T1100119-v1

FSS Modifications

"from eLIGO to aLIGO"

March 7, 2011

Figure 1: Overview of TTFSS schematics with highlighted modifications.

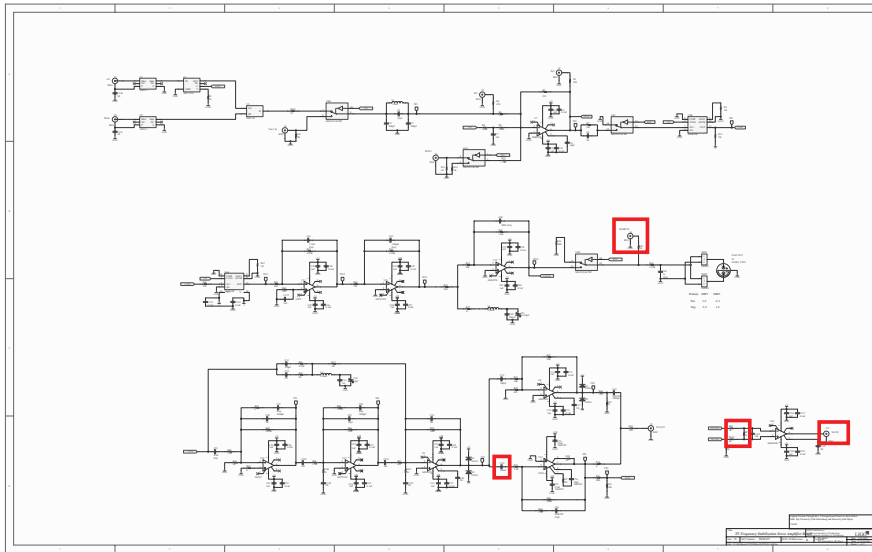
eLIGO is using a TTFSS equipped according to D040105-B. We have to modify the following points, see Fig. 1 for an overview.

1. Replace R96 and R104 by 00hm
2. Replace R97 by 4kOhm
3. Connect J15 (SLOW) with J6 (RAMP IN) using an external BNC cable
4. Replace C29 with daughter board (D1100371) (Fig. 2). Connect ttfssdghtr.X1 to the pad of C29 which has a connection to TP7, connect ttfssdghtr.X2 to the other pad. Connect ttfssdghtr.X5 to TP22 (ground), ttfssdghtr.X3 to TP15 (+5V), ttfssdghtr.X4 to TP16 (-5V).
5. Add PA85 protection circuit according to datasheet (Fig. 4). Solder the diodes to the PA85 socket dangling below the PCB.

Figure 3: Measured transfer function of the TTFSS.

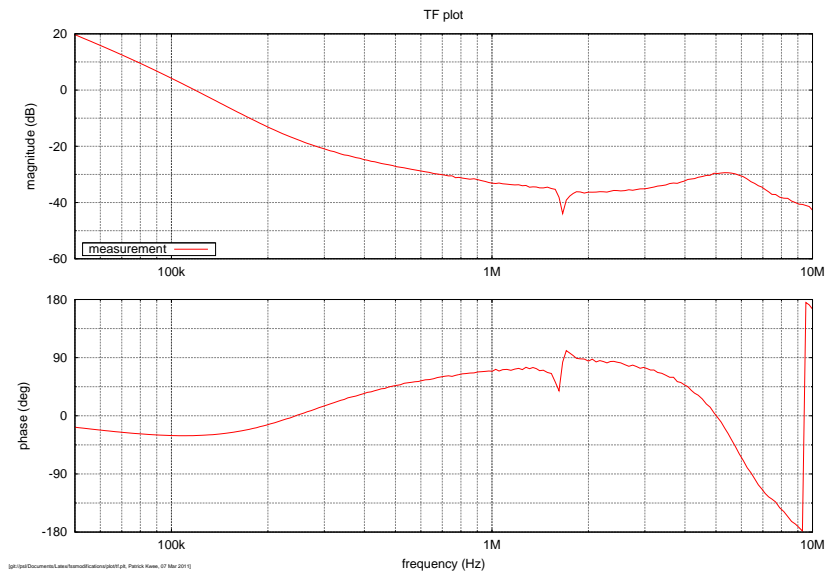
Measure the transfer function from TEST2 (J4) to TP9 to verify the correct installation of the daughter board. Use high impedance inputs at the analyzer, disconnect the RF PD, make sure the loop is closed via EPICS and TEST2 is activated. A reference measurement is shown in Fig. 3, proportional gain might be different.
